#3029945-LU

514-524 FEDERAL AVE E RECOMMENDATION
SHW

514-524 FEDERAL AVE E
SDCI# 3029945-LU

SCHEME C: PREFERRED

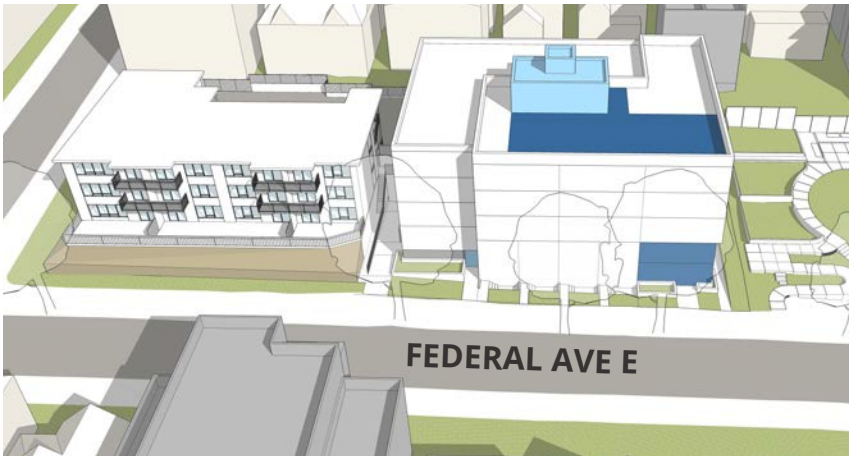
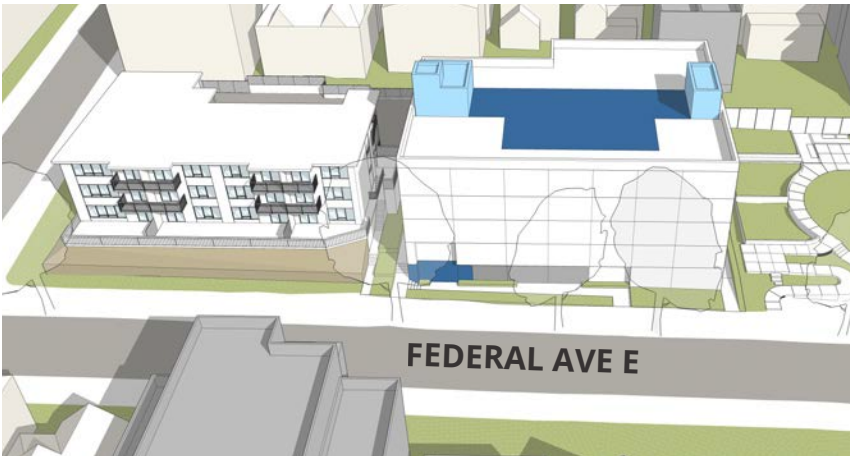
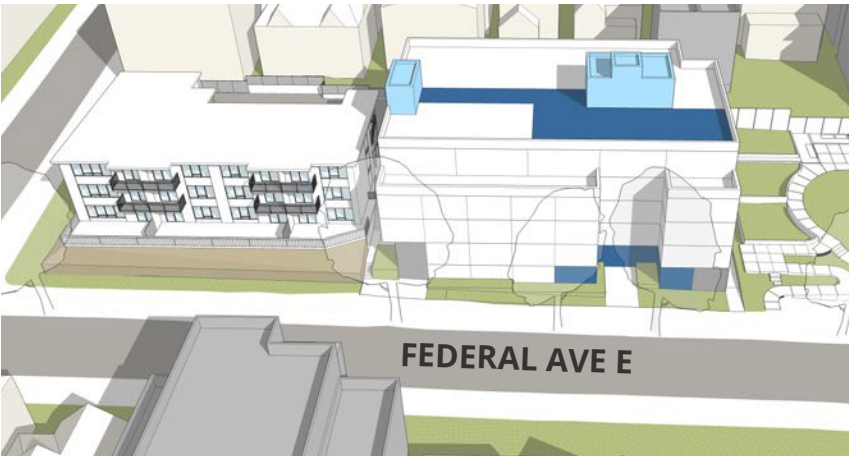
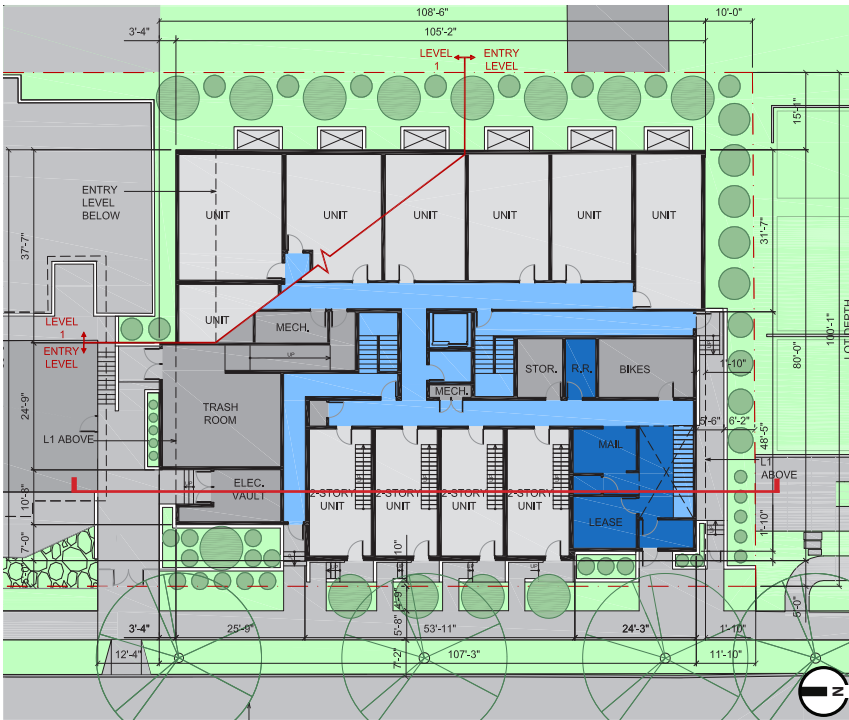
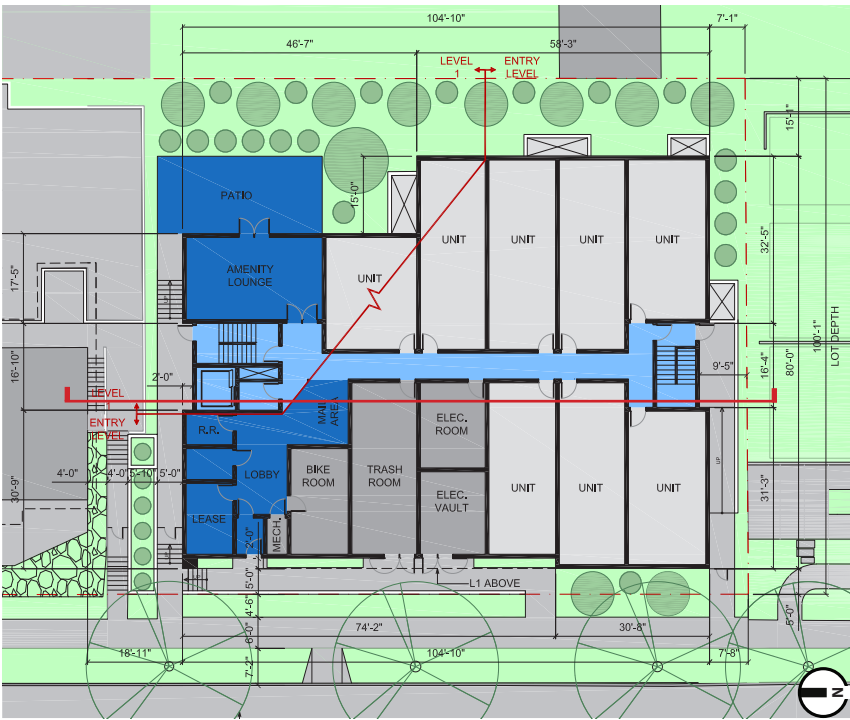
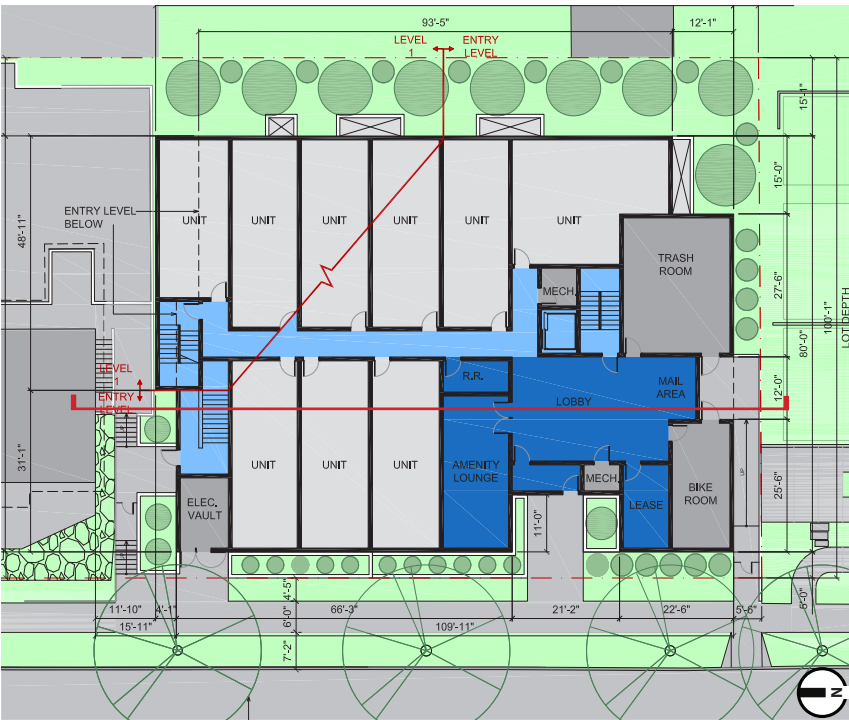
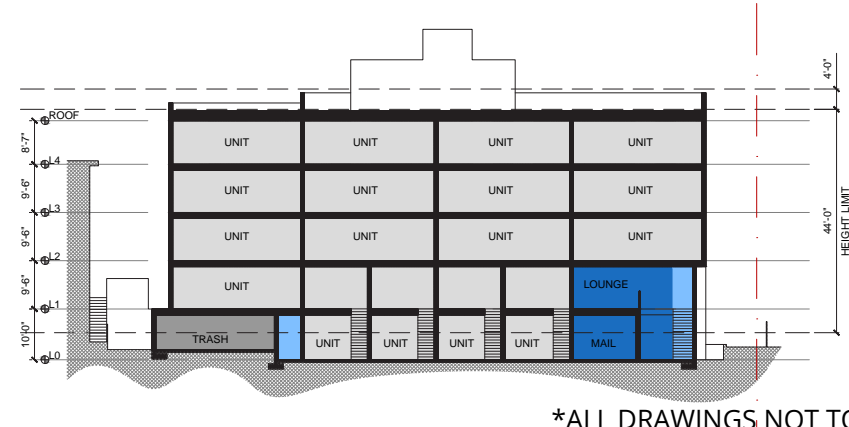
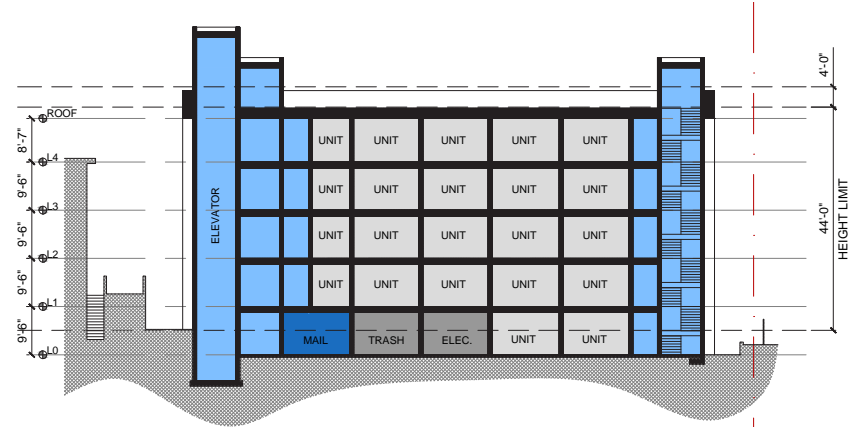
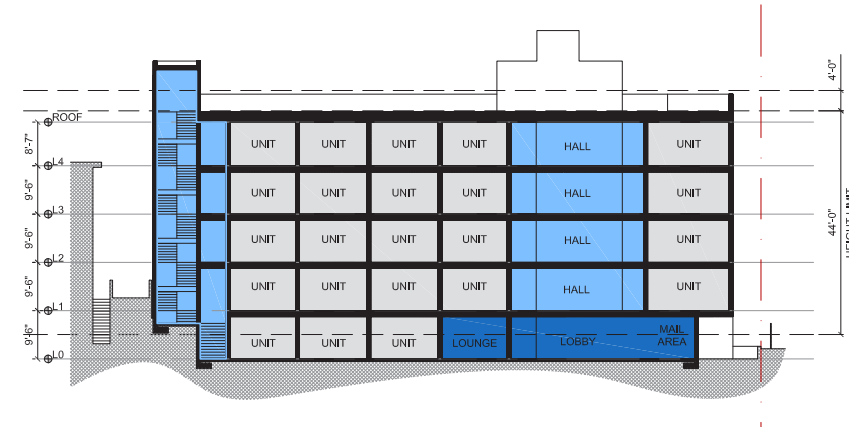
The Board supported the applicant’s preferred Scheme C; a simple composition of three program-driven massing shifts that served to integrate the scale of this new form into the existing context.
- 2

The program-driven massing composition has been retained. Refining the material-to-massing relationship through thoughtful detailing and treatments organizes the forms and doesn't overwhelm the facade. See **PAGE 10** for primary design perspective, **PAGE 20** for entry development, **PAGE 27** for departure justification.
- 2

4 STREET-LEVEL INTERACTION: TOWNHOUSE ENTRIES

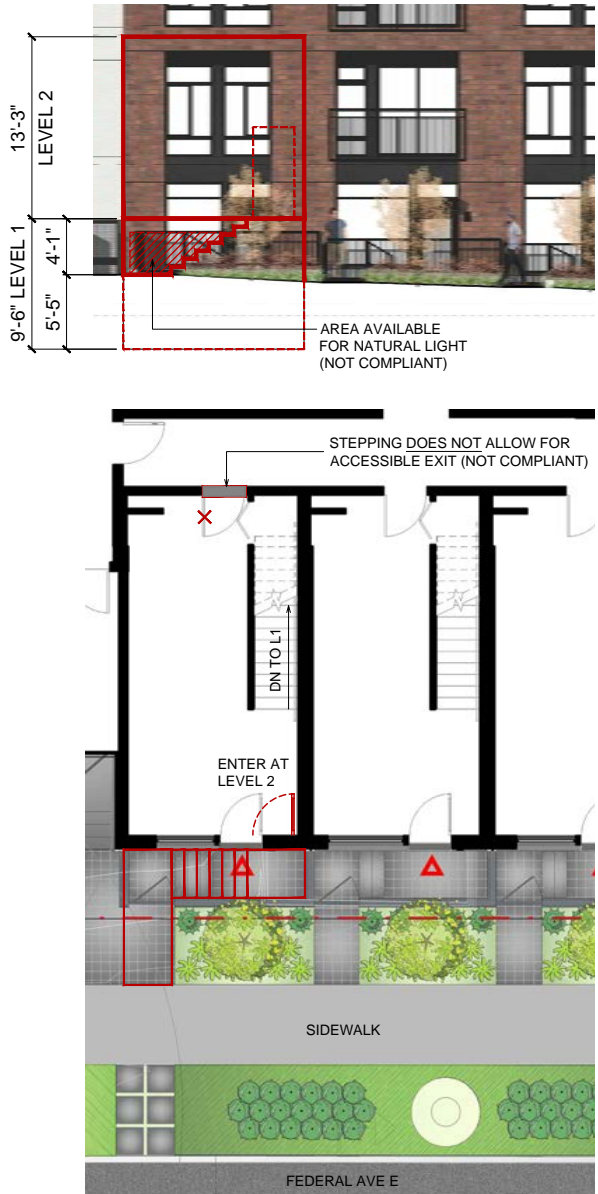
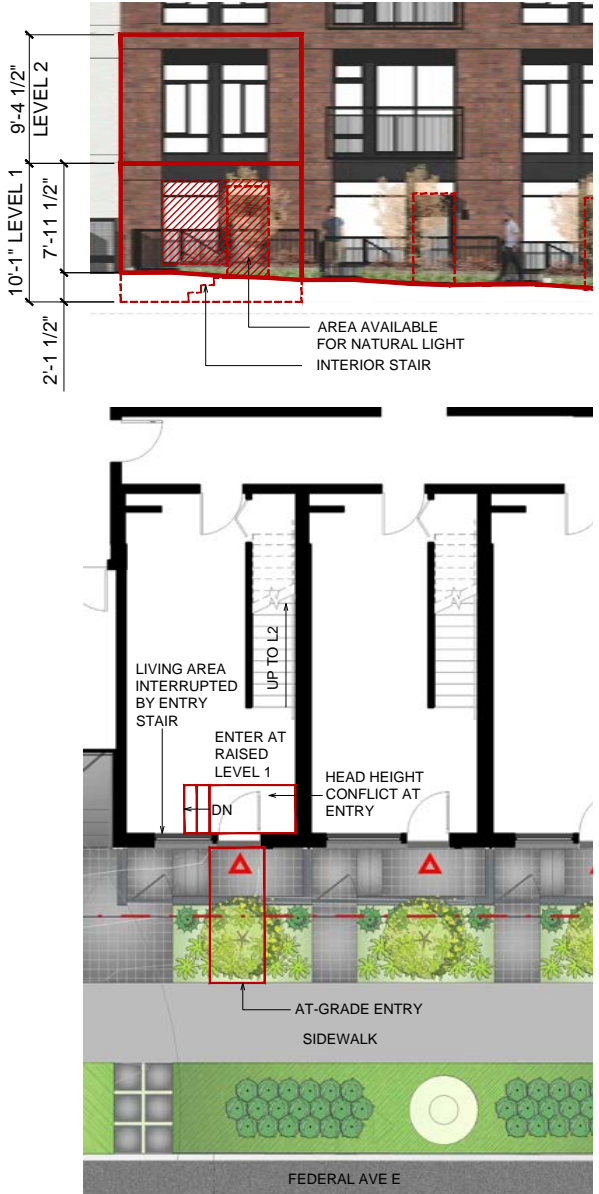
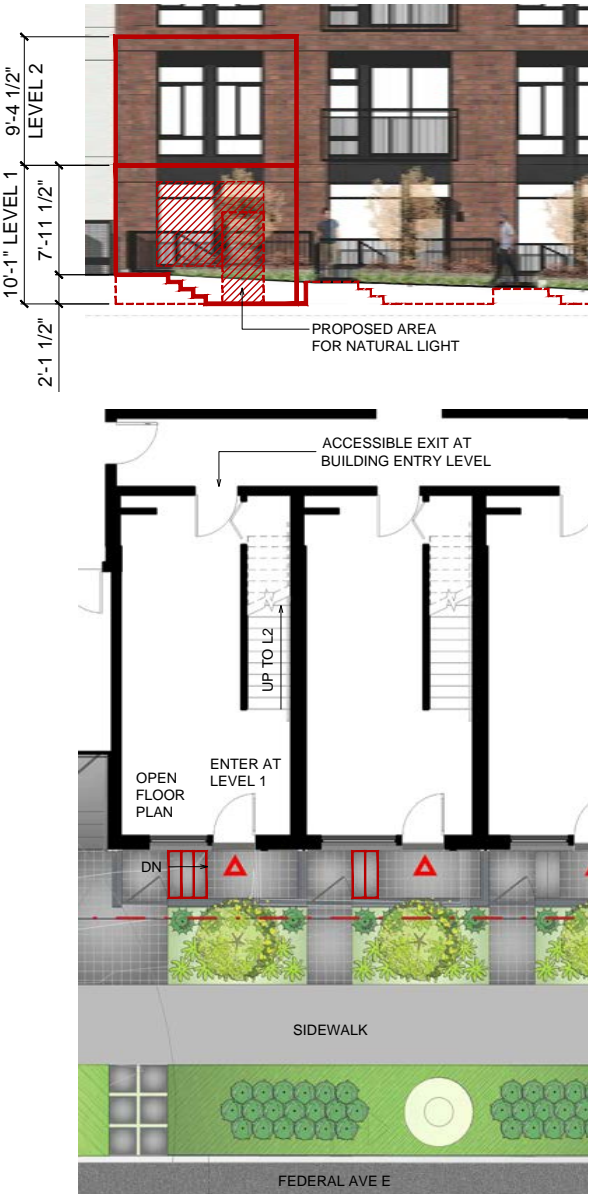
The Board advised referencing historical and local precedent for creating secure but occupiable and welcoming entry areas (stoops, or similar) for these units.
- 5

The “townhome” style unit configuration has been retained. All at-grade units facing the street have direct access from the sidewalk. The grade change from sidewalk-to-entry decreases from 2 feet to 9 inches as you move south. Using local precedents the garden entries are secure with their own entry gates and low perimeter railing. Canopies, lighting and specialty paving provide texture and rhythm along the sidewalk. Raised stoops and direct entries were evaluated. See **PAGE 9** for studies, **PAGE 11** for site plan and **PAGE 21** for street-level entry development.
- 5

- Limited stair run length, entry at upper level required.
- NOT FEASIBLE: Step in unit floor levels required creating a below-grade condition with no viable window opportunities.
- NOT FEASIBLE: Step in unit floor levels does not allow for accessible exit and interior access to building common uses.
- Living and sleeping levels swapped.
- Door and window location would require an interruption at the brick framework.

- Does not provide grading variation as a physical and visual transition between sidewalk and entry per guideline CH-PL3.2a.
- NOT CONSISTENTLY FEASIBLE: Two of the four entries do not meet head height clearances at the raised interior entry.
- Occupiable area available next to entry but would be hard to secure. Not enough frontage for direct gate to entry door sequence.
- Less eyes on the street. Stair overwhelms the interior pushing living spaces away from the windows.

- Grading variation at garden entry.
- Highest transparency yield at the street.
- Entry gate and low-barrier railing secure and define the entries.
- Elevations express consistent floor lines and window patterns at regular intervals (no stepping).
- Open interior living space has strong visual connection to the street.
- See **PAGE 21** for additional concept analysis.

RESIDENTIAL EDGE: PARK

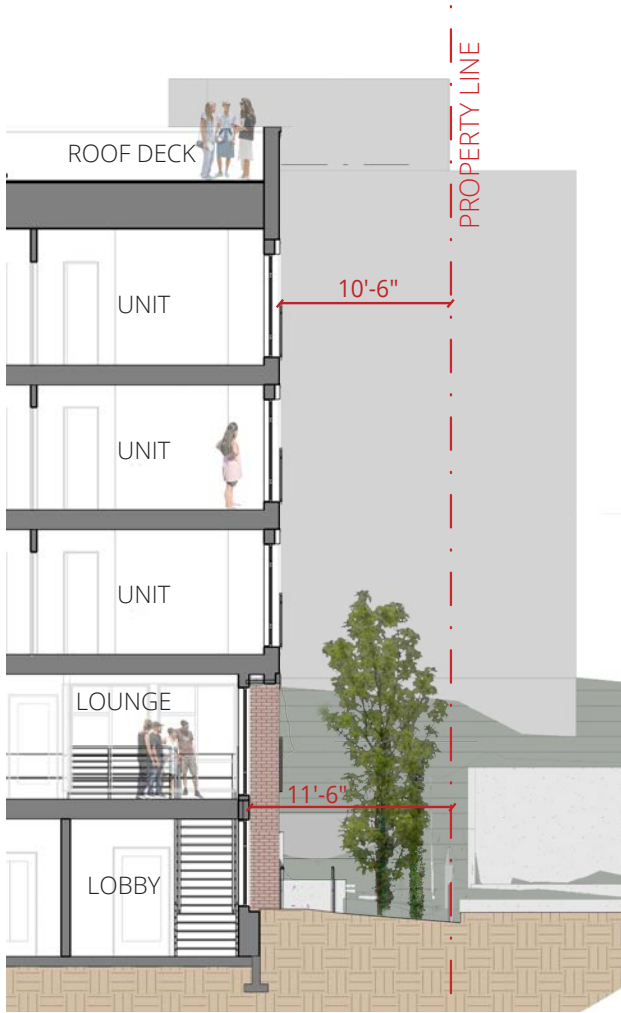
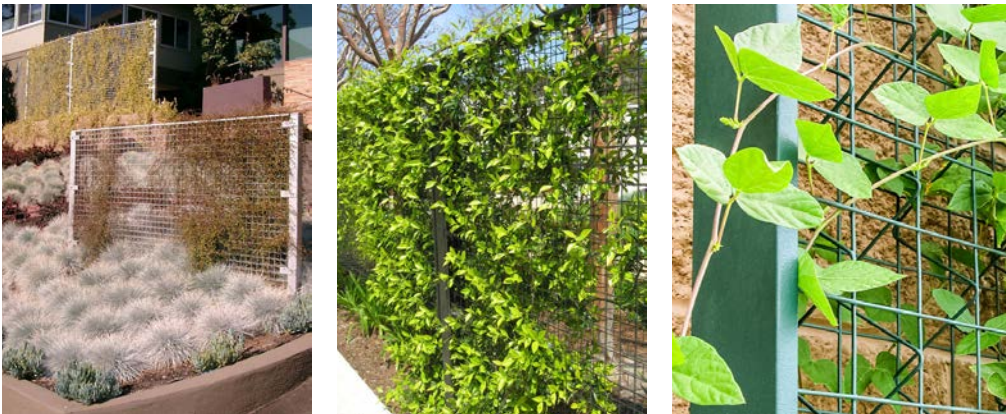
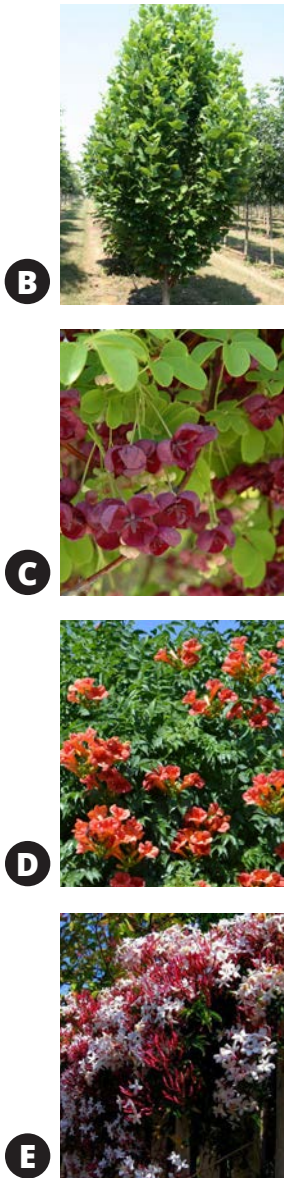
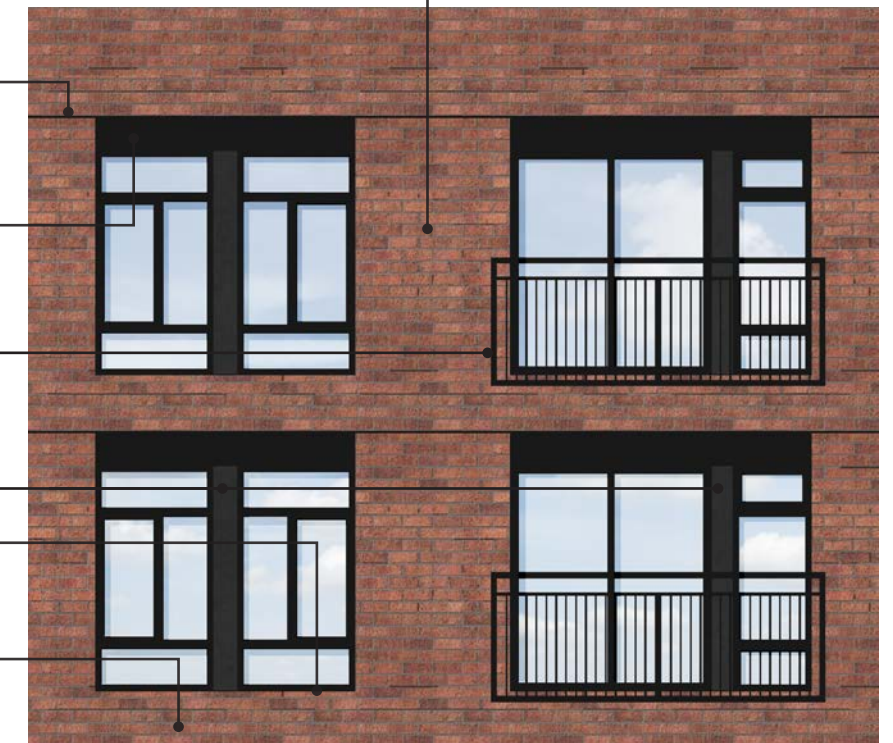
The Board echoed concern expressed by neighbors about how the project meets the park and its potential to overwhelm the publics’ experience of that space. To mitigate this potential effect, the Board recommended consideration of an upper-level setback at the park edge, a change in the expression/pattern of fenestration and/or a subtle massing shift at the park to reflect the different condition, a larger setback at the park edge, the size, species and spacing of trees in the setback, and how those trees can help to buffer that edge, a physical ‘engagement’ with the park that is not simply visual, possibly by creating outdoor space at the balconies (similar to those at Hugo House), and the creation of a ‘front porch’ outdoor space at the corner entry.
- 3

The design intent is to maximizes a larger than required setback adjacent to the park. A 10’ minimum setback from the park edge is provided where a 5’ min, 7’ avg is required. See **PAGE 9** for study of a code minimum setback with covered decks. Landscaping features at the setback include columnar trees and 8’ tall green screens with multiple species of vines. The trees provide a prominent fall color, and the vines are used in combination for year-round interest. These elements work together to complete the park edge, reduce the perceived scale of the building from grade, and provide a buffer for the residential units facing the park.

The units feature large openings facing the park, including sliding doors with Juliet balconies. These balconies provide texture to compliment the materiality of the brick. A wider side setback was chosen over pushing the massing to the setback minimum to provide decks. A generous roof deck with social spaces overlooking the park will provide additional physical engagement and eyes on the park.

- Juliet balconies, windows, flashing and vent covers are finished (black) and detailed to add depth and recess at the brick. Durable, high quality materials face the park. *DC2 B.1: FACADE COMPOSITION*
- Perceived building mass is reduced by the transparency and materiality of the 2-story entry volume. *DC2 A2: REDUCING PERCEIVED MASS*
- The park environment is improved with additional activity at the north edge. New residents equal eyes on the park. This increases safety and security and invites neighbors to engage with park amenities. *PL1.C1 SELECTING ACTIVITY AREAS, PL2 B.1: EYES ON THE STREET*
- Creating a complimentary edge: continuing the park's east retaining wall language with vertical landscape screening and tree placement. *CH-PL1 1A: ENHANCING OPEN SPACE*
- Integrated direct access to the bike parking room along the south edge. *PL4 B.2: BIKE CONNECTIONS*

RESIDENTIAL EDGE: NORTH NEIGHBOR

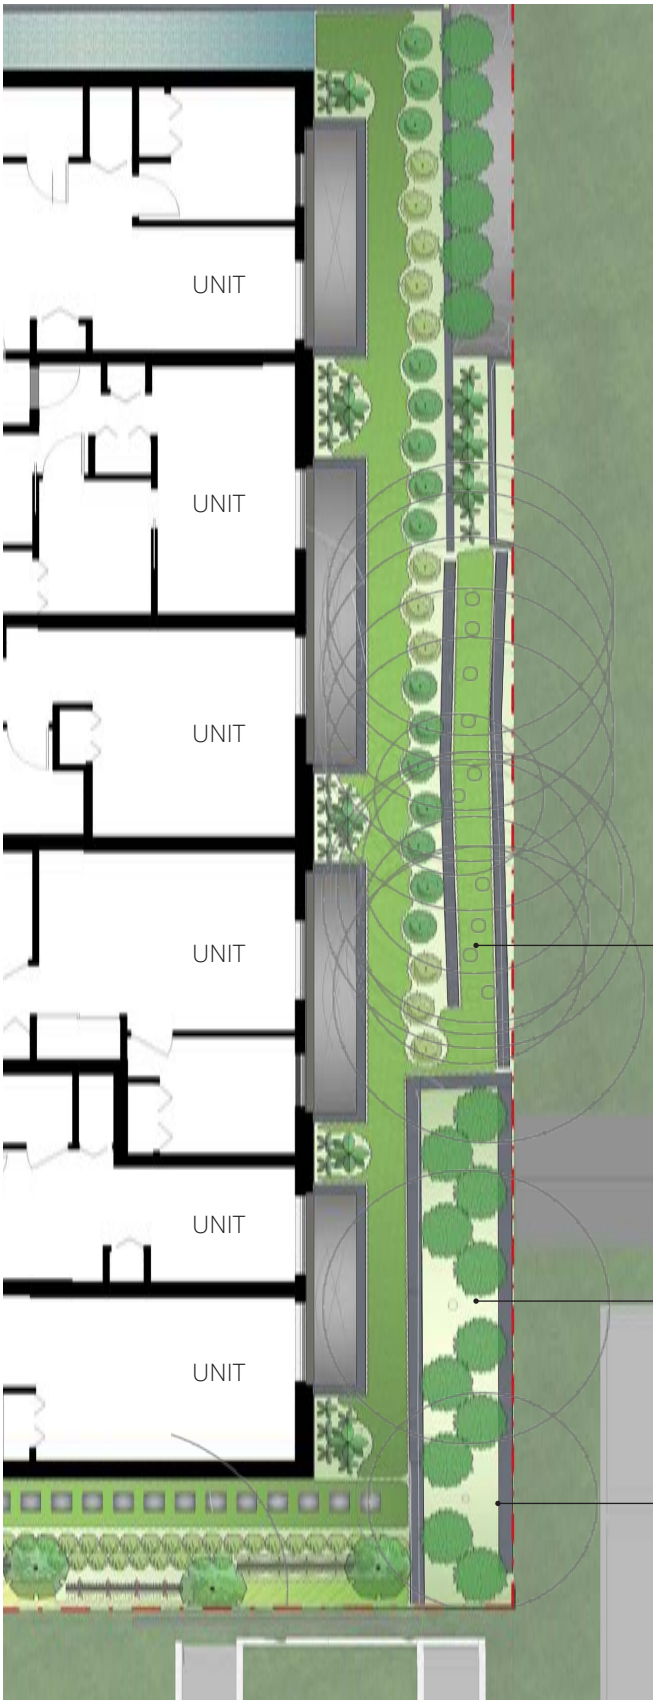
The Board expressed concern regarding the north side yard and recommended exploring options to eliminate (or better design) the fence for both utility and security.
- 6

For security reasons this area cannot be left open. The gate and screening have been redesigned to be secure but transparent. Landscaping frames the access gate and softens the building edges. No utility or service access doors are visible from the street. See **PAGE 11** for site plan and **PAGE 22** for residential edge development.
- 6

- PERFORATED METAL INFILL PANEL
- ALUMINUM FRAME W/ BLACK POWDER COAT FINISH
- GATE DESIGN REFLECTS WINDOW PATTERN
- TIMBER FRAMEWORK, EBONY STAIN
- SPANNING CABLES OVER PLANTER FOR SECURITY
- BIO-RETENTION PLANTER TREATS STORMWATER RUNOFF
